**SUBJECT: PERRY NUCLEAR POWER PLANT, UNIT NO. 1 - ISSUANCE OF
AMENDMENT REGARDING TECHNICAL SPECIFICATION CHANGES TO
PERMIT INSTALLATION OF UPPER CONTAINMENT POOL GATE AND
DRAIN-DOWN OF REACTOR CAVITY PORTION OF UPPER CONTAINMENT
POOL (CAC NO. MF7476) (L-16-083)**

Amendment No. 174
License No. NPF-58

SAFETY EVALUATION BY THE OFFICE OF NUCLEAR REACTOR REGULATION
RELATED TO AMENDMENT NO. 174 TO FACILITY OPERATING LICENSE NO. NPF-58
FIRSTENERGY NUCLEAR OPERATING COMPANY
FIRSTENERGY NUCLEAR GENERATION, LLC
PERRY NUCLEAR POWER PLANT, UNIT NO. 1
DOCKET NO. 50-440

Figure 3.10.9-1
Upper Containment and Suppression Pool Levels

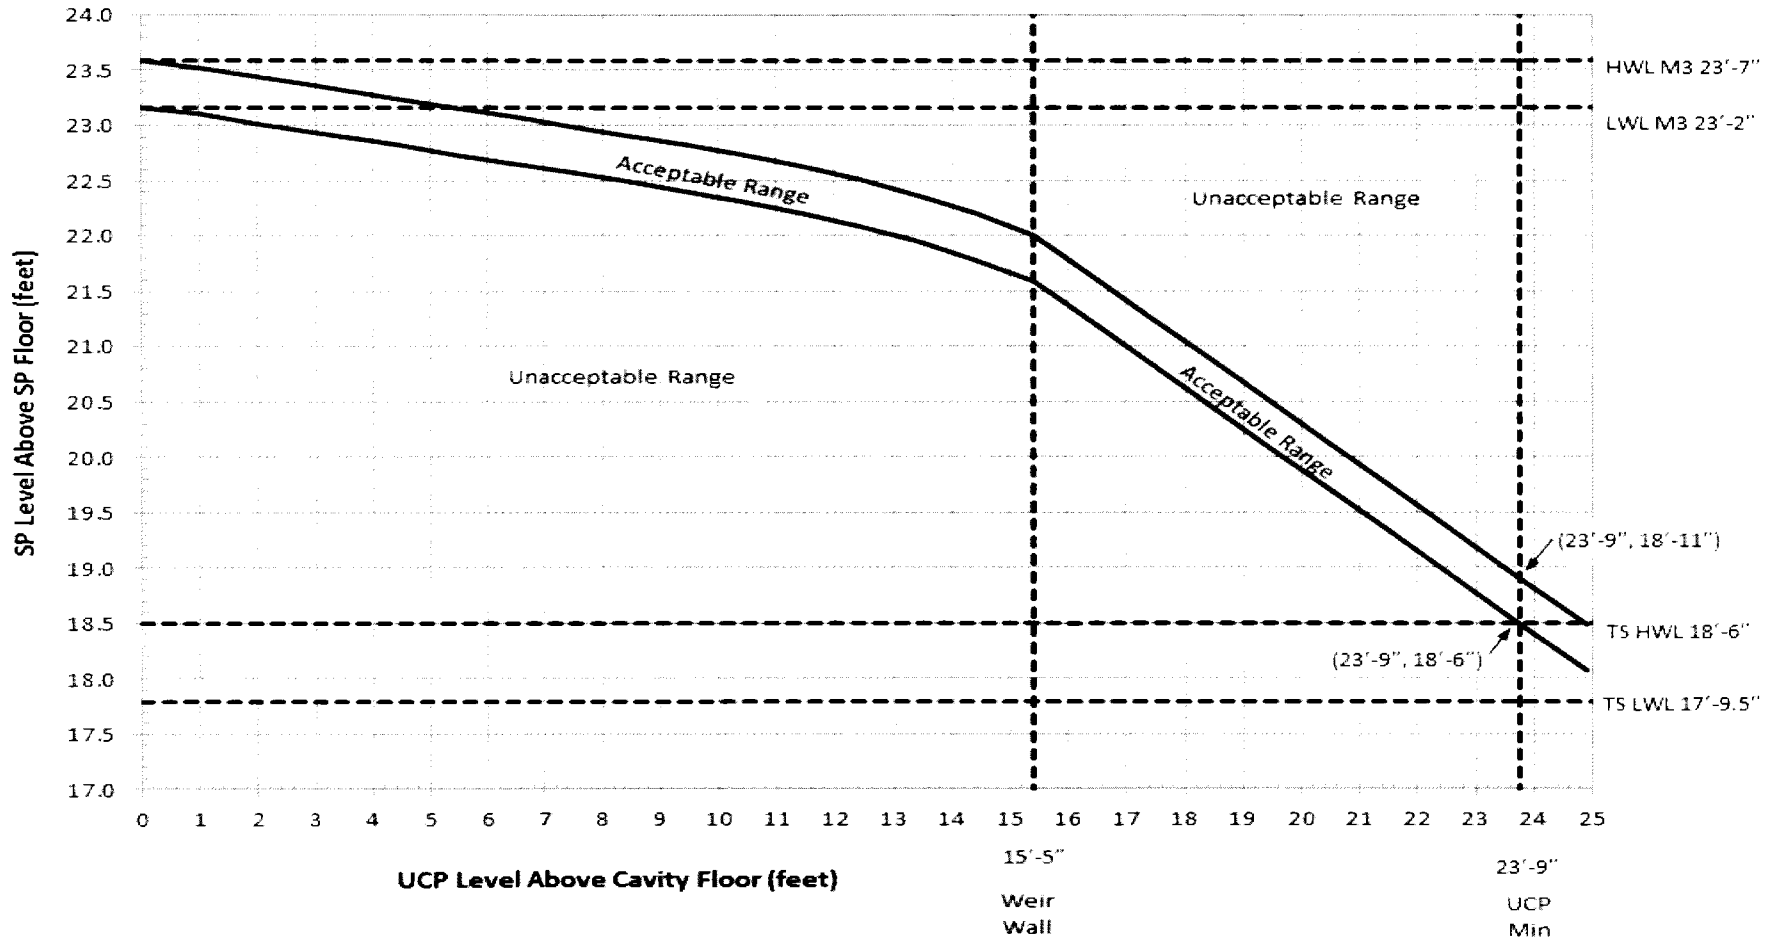
Figure 3.10-9-1, "Upper Containment and Suppression Pool Levels," is also added, but is not reproduced here. Figure 3.10.9-1 provides the acceptable range of suppression pool level above the suppression pool floor (in feet) as a function of UCP level above the cavity floor (in feet).

The suppression pool LWL will need to be increased by 5.4 inches + 0.3 inches (accounting for level instrument uncertainty) to a new lower limit of 18 feet 3.2 inches when the reactor well to steam dryer storage pool gate is installed in MODES 1, 2, and 3. If the MODE 3 drain-down of the reactor cavity portion of the UCP is conducted, the suppression pool LWL will need to be increased in accordance with new TS Figure 3.10.9-1.

If the MODE 3 drain-down of the reactor cavity portion of the UCP is conducted, the suppression pool HWL will need to be increased in accordance with new TS Figure 3.10.9-1.

The SRs associated with LCO 3.10.9 include verification of suppression pool temperature, reactor steam dome pressure, levels in the Acceptable range of Figure 3.10.9-1, levels in the steam dryer storage pool and the fuel transfer pool areas of the UCP are sufficiently above the reactor vessel flange, location of the IFTS carriage, and closure of the IFTS transfer tube shutoff valve.

- a. Suppression pool average temperature is $\leq 110^{\circ}\text{F}$;
 - b. Suppression pool and upper containment pool water levels are maintained within limits of Figure 3.10.9-1;
